Metro Martin Place

Over Station Development Design Integrity Report North Site

JUNE 2020

MARTIN PLACE OSD DRP – SESSION 13 05.05.20

Figure 1 – Comparison of DA approved and proposed Level 10 eastern external terrace arrangement

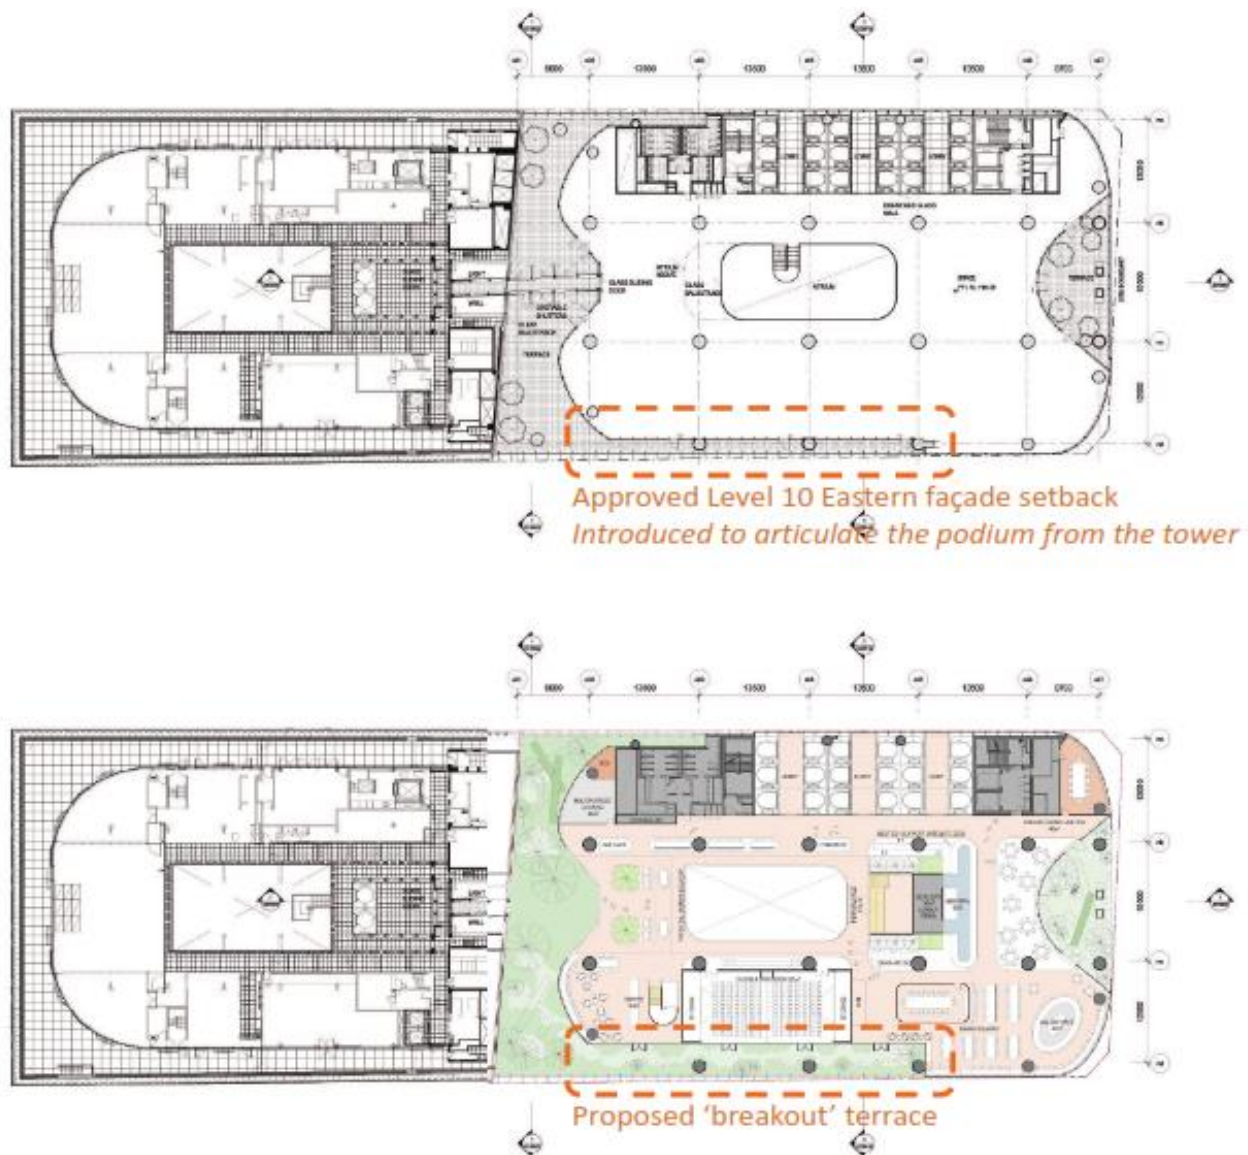
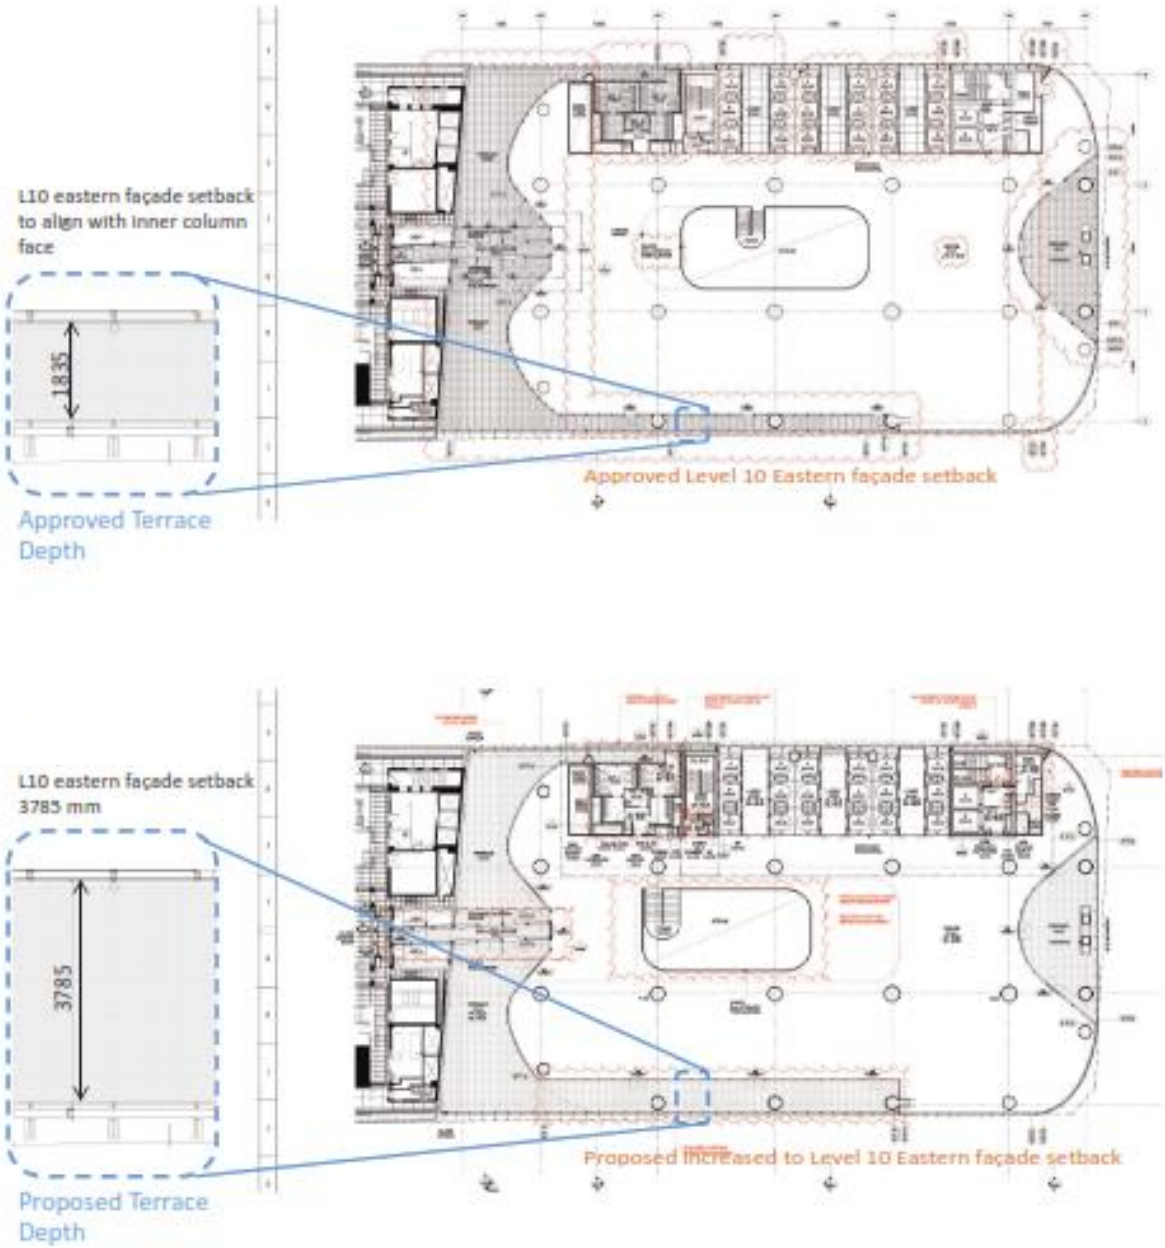
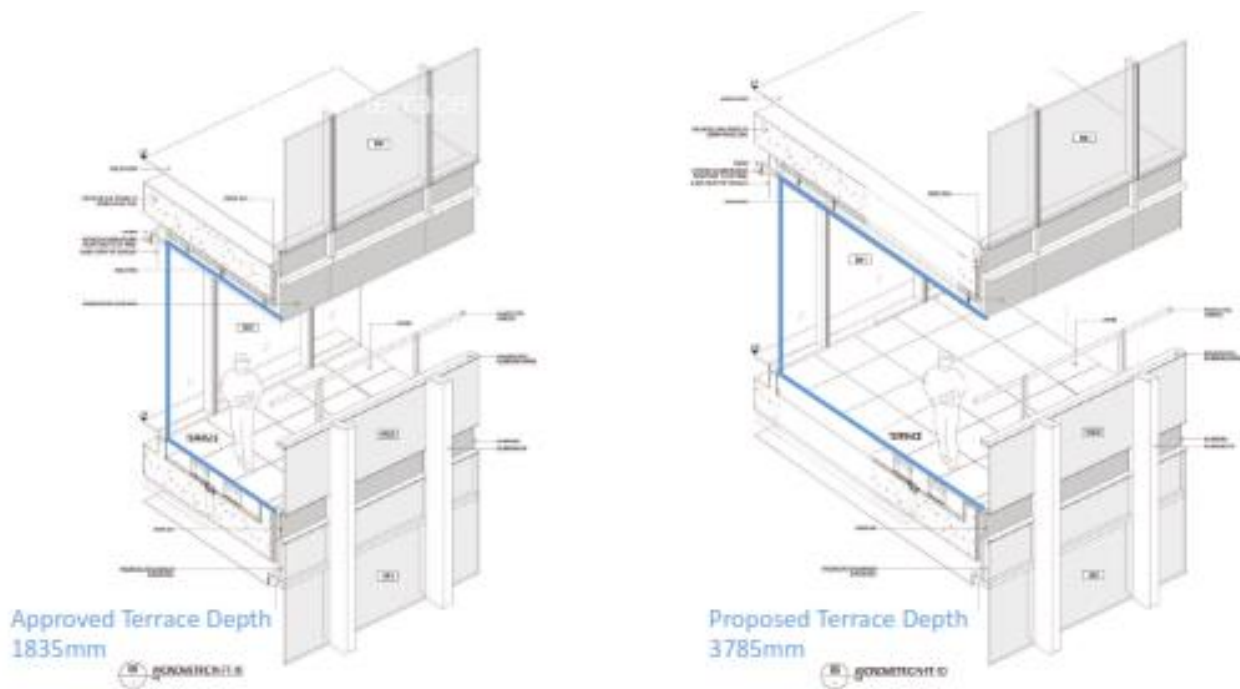
The Level 10 eastern external terrace is currently approved to be 1,835mm wide. The terrace depth is proposed to be widened to 3,785mm, representing an increased width of 1,950mm.

The increased eastern external terrace will facilitate an enlarged space with greater amenity, a more generous outdoor space, and a strengthening of the street wall of Elizabeth Street through a deeper recess.

The detailed design of L10 has identified this terrace as a suitable breakout space. Accordingly, the depth of the terrace is proposed to be increased from 1,835mm to 3,785mm. A landscape proposal which supports the use of the terrace as a breakout space is being developed.

The panel supports the change, noting the positive impact to the approved project.

Figure 5 – Comparison of DA approved and proposed Level 3 and 4 spandrel relocation

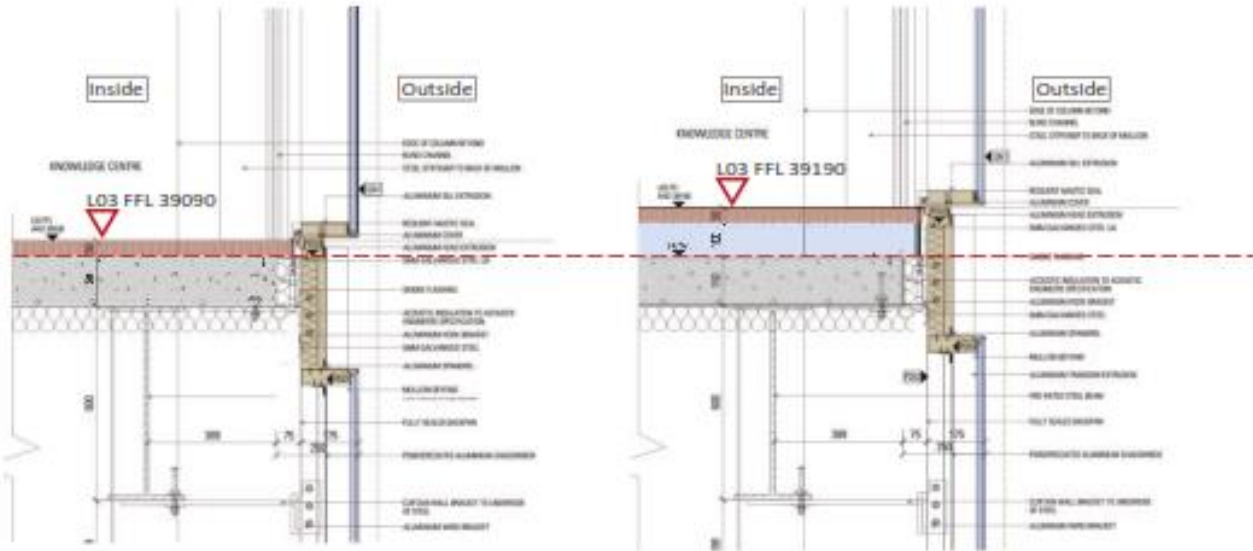
A minor increase in the spandrels on Levels 3 and 4 of the eastern, northern and western facades of the building are proposed to be increased. This amendment responds to the outcomes of a servicing review, which recommended an increase in the floor finishes zone on these Levels 3 and 4 by 100mm. The additional floor finishing requires an increase in the height of the transom, and a subsequent increase in the height of the spandrels on Level 3 and 4. The increase is not discernible in the context of the overall façade.

L3 and L4 of the North Tower will be a knowledge centre. The FFL of these floors is proposed to be raised by 100mm to provide service access and enable a flexible fit out.

To ensure the internal change has no significant impact on the façade, the position of the stacked joint between the skirt and L3, and L3 and L4 will be raised by 100mm.

The panel supports the change, noting there is no discernible impact to the approved project.
